NOTICE OF VIOLATION

Florida Power & Light Company
St. Lucie Nuclear Plant

Docket No. 50-335
License No. DPR-67
EA 98-513

NRC Inspection Report Nos. 50-335, 389/98-14
Pre-Decisional Enforcement Conference
January 7, 1999
Atlanta, Ga.

Unit 1 Electrical Equipment Room Layout

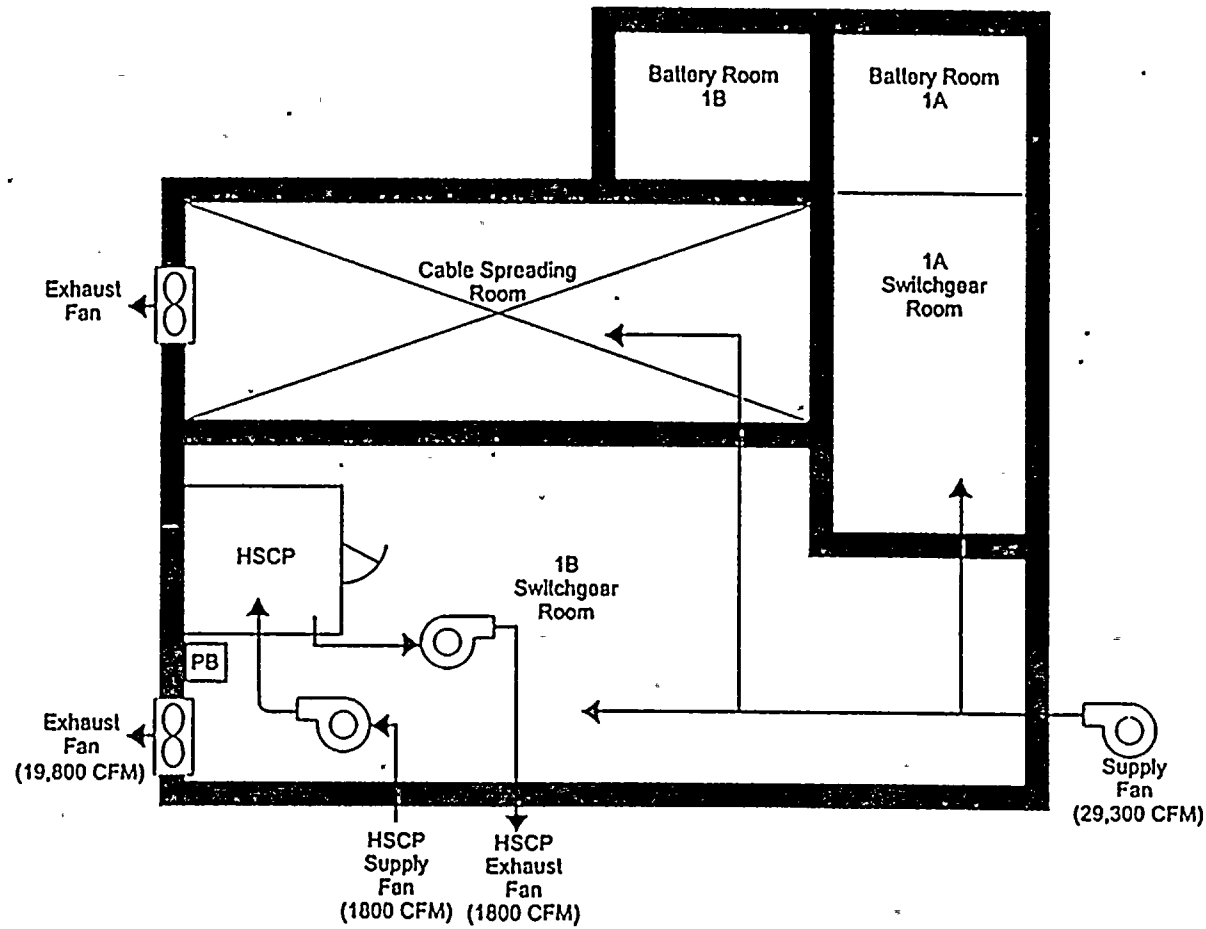
Apparent Violation 1

Issue - Original Unit 1 SSA and Alternate Shutdown Procedure Did Not Adequately Address HSCP Habitability

Issue - Original Unit 1 SSA and Alternate Shutdown Procedure Did Not Adequately Address HSCP Habitability

- **Cause - Original SSA Deficiency**
- **Corrective Actions**
 - ◆ **Immediately Revised Alternate Shutdown Procedure to Include HVAC Manual Actions**
 - ◆ **Added HSCP Fans to Essential Equipment List**
 - ◆ **Modifications Planned for HSCP Fan Circuits (1999)**
 - ◆ **Continuous Fire Watch Remains in Place (Cameras)**

- **Within Scope of In-Progress SSA Revalidation - Credit for Self Identification Warranted**
- **Safety Significance - Low**
 - ◆ **HVAC Analyses Demonstrate Up to Three Hours Available to Restore Ventilation to Ensure Habitability**
 - ◆ **Existing Emergency Operating Procedure Includes Appropriate HVAC Manual Actions**
 - ◆ **Increase in Core Damage Frequency (CDF) < 1.0E-7/Yr**

Unit 1 Charging Pump Cubicle Layout

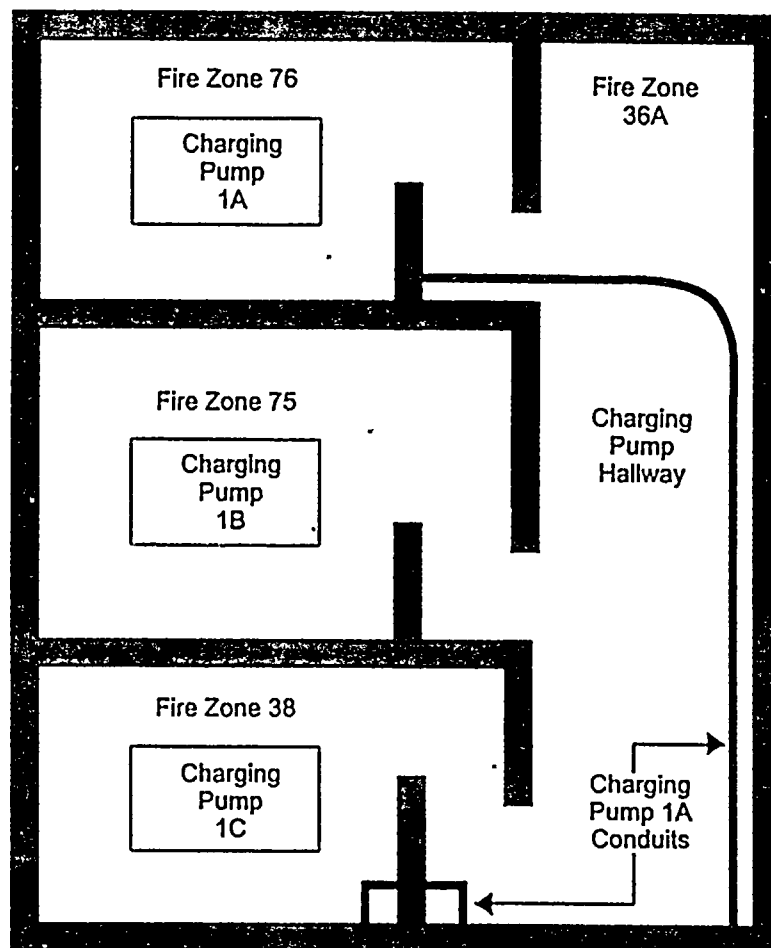
Apparent Violation 2

Issue - Self Assessment Identified That Charging Pump 1A Circuits Not Protected as Required by Original Exemption

Issue - Self Assessment Identified That Charging Pump 1A Circuits Not Protected as Required by Original Exemption

- Documented Prior to FPI in CR 98-0188 and LER 98-005
- Cause - Inadequate Implementation of an Original Fire Protection Exemption
- Corrective Actions
 - ◆ Completed Control Circuit Reroute (10/98)
 - ◆ 1A Charging Pump Power Cable Protection in Progress - Complete by 3/99
 - ◆ Continuous Fire Watch Remains in Place (Cameras)

- **Safety Significance - Low**
 - ◆ Available Alternate Reactor Coolant System (RCS) Makeup Source Via High Pressure Safety Injection (HPSI) Pumps
 - ◆ EOPs in Place to Use HPSI Pumps
 - ◆ Increase in CDF $< 1.0E-7/Yr$

Unit 1 Reactor Coolant Gas Vent System

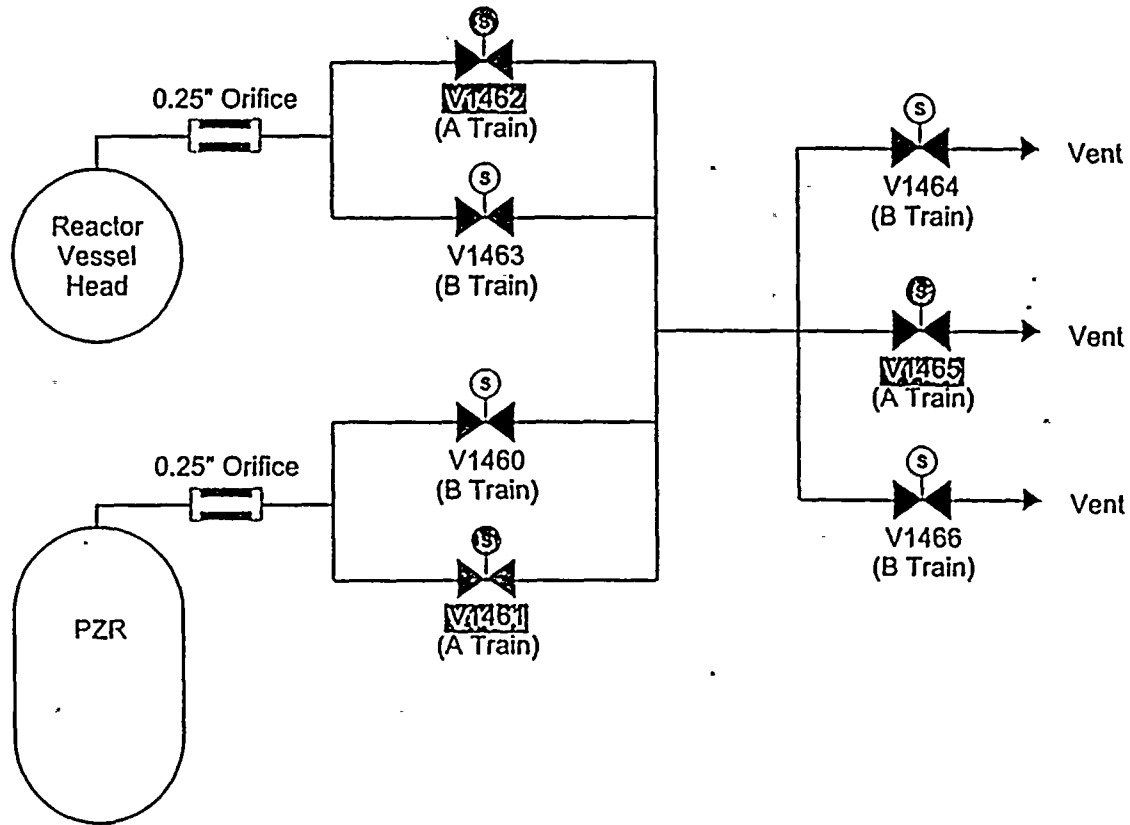
Apparent Violation 4

Issue 2 - Inadequate Implementation of HLPI Protection

- **Second Example - Potential for Fire Induced Spurious Operation of Unit 1 and 2 Reactor Coolant Gas Vent System (RCGVS) Valves**
 - ◆ **Self Assessment Identified That Original SSA Lacked Detail for RCGVS Spurious Operation**

- **Cause - Original SSA Documentation Inadequate**

Issue 2 - Inadequate Implementation of HLPI Protection - Second Example

- **Corrective Actions**
 - ◆ Immediately Developed Procedural Actions for Both Units to Mitigate Spurious RCGVS Operation
 - ◆ Modified Unit 2 RCGVS Circuits During Outage (12/98)
 - ◆ Unit 1 RCGVS Circuits to Be Modified in 1999 Outage

- **Safety Significance - Low**
 - ◆ RCS Inventory Loss Within Charging Pump Capacity
 - ◆ Increase in CDF < 1.0E-8/Yr

Unit 2 Shutdown Cooling System

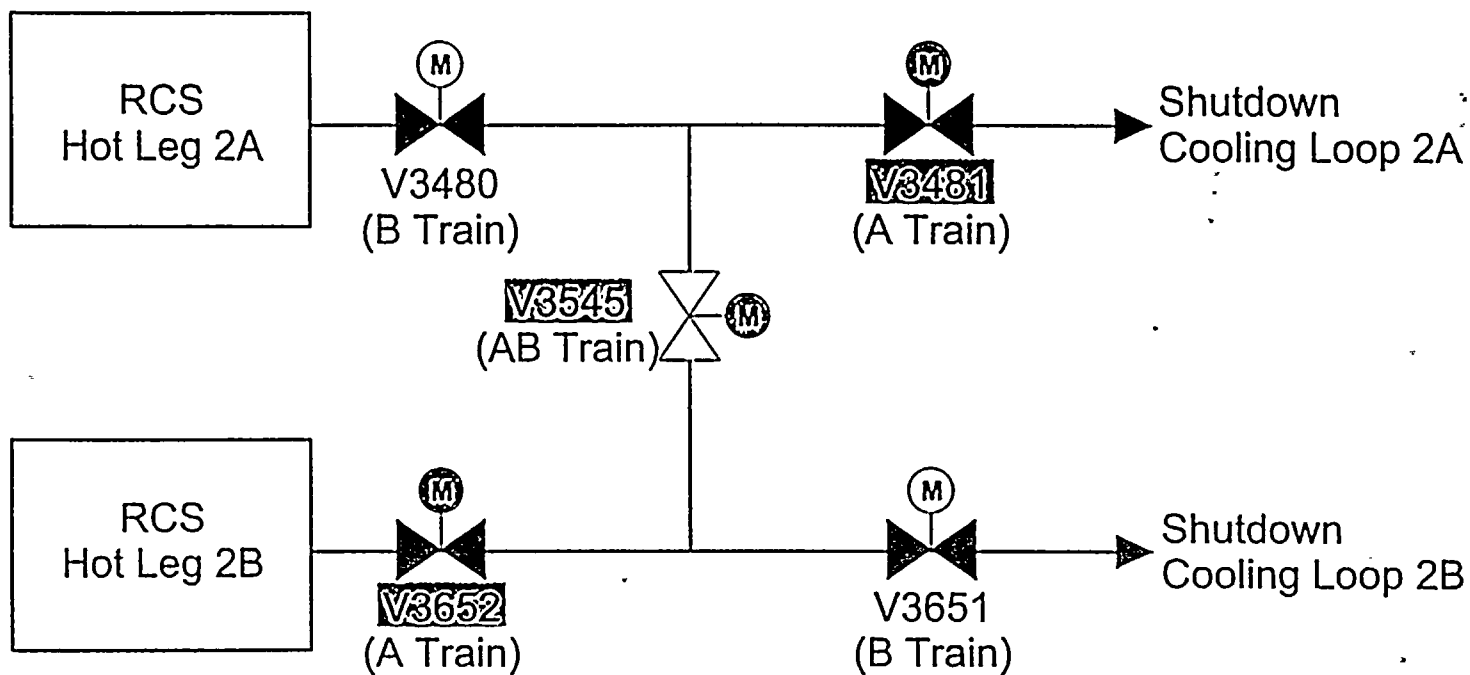
Apparent Violation 4

Issue 2 - Inadequate Implementation of HLPI Protection

- Third Example - Inadequate Evaluation of Unit 2 Shutdown. Cooling System (SDC) Motor Operated Valves (MOVs)
 - ◆ Self Assessment Identified That HLPI Protection Removed by Previous Plant Modification

- Cause - Inadequate Consideration of Existing Fire Protection Requirements During Modifications to Meet GL 95-07 Requirements

Issue 2 - Inadequate Implementation of HLPI Protection - Third Example

- **Corrective Actions**
 - ◆ **Implemented Modification to Protect SDC System Valves During Unit 2 Outage (12/98)**

- **Safety Significance - Low**
 - ◆ **Failure Mode Not Credible**
 - **All Valves Normally Deenergized**
 - **Two MOV Failures Required**
 - **Correct Polarity 480V 3-Phase Cable Faults Required**
 - ◆ **CDF Increase < 1.0E-7/Yr**
